# Rezoning Transportation Analysis

Petition Number: 2019-001c

General Location Identifier: 22345181, 22345195

Revision Log:	Date	Description
	01-31-2019	First Review
	03-12-2019	Second Review
	04-25-2019	Third Review

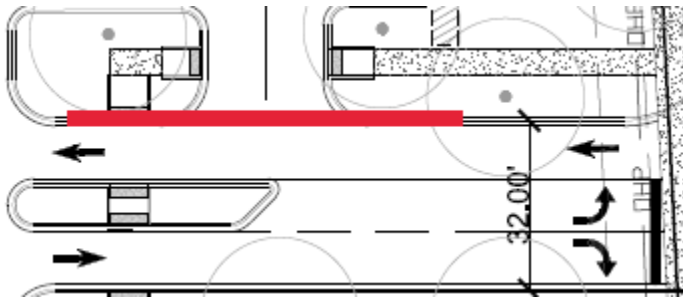
- ~~**Curbline** The proposed zoning district has a setback measured from back of the existing or proposed future curbline. The location of the future back of curb will be located 38' from Lancaster Highway centerline. The petitioner should update the site plan and conditional note(s) to commit to construct the curb and gutter, widening, and sidewalk.~~
